Access Compliance Report

Public Rights-of-Way

(Curb Ramps)

Intersection ID: 11318	Main Street: GRANDIN_RD	Cross Street: W_4TH_ST_EXT	Location: SW
ADA ID: C077C5FF0000	Ramp Type: Perp	Initial Pass/Fail: Pass	Overall Compliance: No
Severity Score: 0			
Codes/Mitigation Info/Possible Solution		Field Measurements/Component Compliance

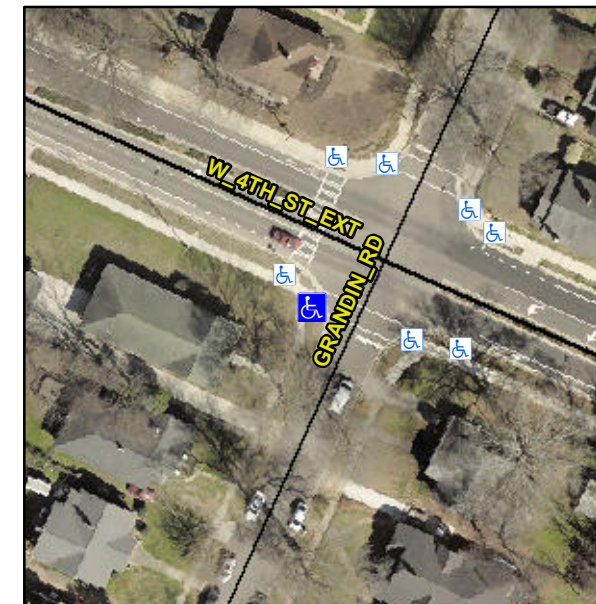
Not Found, R304.2.1, R305.2

Compliance	Description	Data	Compliance	Description	Data
N/A	Ramp Length (in)	44.0	Yes	Ramp Slope (%)	6.7
Yes	Ramp Width (in)	70.0	Yes	Ramp XSlope (%)	1.1
Yes	Flare Type L	Curbed_NoWalkSurface	Yes	Flare Type RT	N/A
Yes	Flare Slope LT (%)	N/A	N/A	Flare Slope RT (%)	N/A
N/A	Flare Traversable LT?	No	N/A	Flare Traversable RT?	No
No	Landing Length (in)	46.5	Yes	DWS Provided?	Yes
Yes	Landing Width (in)	70.0	Yes	DWS Contrast?	Yes
Yes	Landing Slope (%)	1.2	Yes	DWS Length (in)	24.0
Yes	Landing X Slope (%)	0.8	Yes	DWS Full Width?	Yes
N/A	Landing Curb? (Y/N)	No	No	DWS Offset (in)	2.5
N/A	Shared Landing?	No			
Yes	Gutter Ponding?	No	Yes	Gutter Slope (%)	2.6
Yes	Gutter Lip Ht (in)	0.0	Yes	Gutter X Slope (%)	0.8
N/A	Painted X Walk1?	No	N/A	Painted X Walk2?	N/A
	X Walk 1 Direction	To SE		X Walk 2 Direction	N/A
N/A	X Walk 1 Width (in)	N/A	N/A	X Walk 2 Width (in)	N/A
	X Walk 1 Slope (%)	0.0		X Walk 2 Slope (%)	N/A
	X Walk 1 X Slope (%)	0.9		X Walk 2 X Slope (%)	N/A

N/A	Ramp inside XWalk1?	N/A	N/A	Ramp inside XWalk2?	N/A
	Road Slope (%)	N/A	N/A	Clear Space?	Yes
	Road X Slope (%)	N/A	N/A	Clear Space to XWalk (in)	N/A
Yes	Any Obstructions?	No	Yes	Storm Grate/Utility Hazard?	No
	Obstruction Type			Storm Grate/Utility Type	
		N/A			N/A
			Yes	Surface Condition? (G/P)	Good

Possible Solutions:

Remove & Replace Entire Ramp.
